C L E P A
*European Association of
Automotive Suppliers*

CLEPA proposal belt installed CRS

March 9, 2017.

R129 criteria belt installed CRS

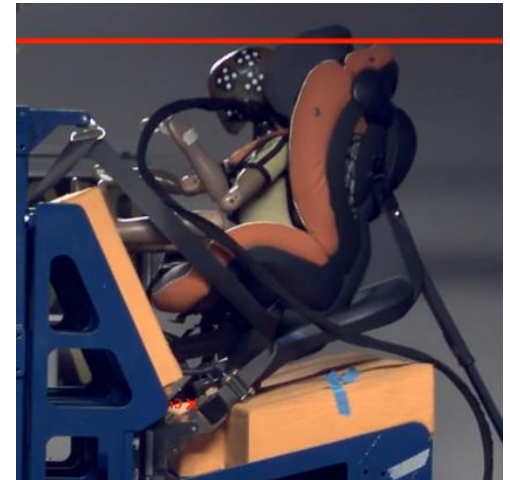
From crash test, executed with R44-04 belt installed seats under R129 test conditions the following can be concluded:

For large toddler rear facing belt installed seats, ***it's impossible*** to comply with a vertical head displacement of 800 mm. in a rear impact and difficult to comply in the rebound of a frontal impact.

Proposal:

Define 840 vertical head displacement for all dummies

Rational: If we accept this for Q10 dummy, why should we not accept it for other dummies?

Figure 1
Arrangement for testing a forward-facing device

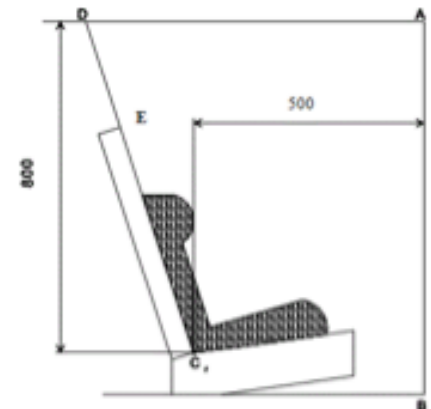
Head excursion: No part of the head of the dummy shall pass beyond the planes BA, DA and DE as defined in Figure 1 below . This shall be judged up to 300 ms or the moment that the dummy has come to a definitive standstill whatever occurs first. Except for booster seats when testing using Q10 dummy where :

The value in relation to the DA plane is 840 mm.

Proposal: Adjust the vertical displacement to 840 mm. for all dummies.
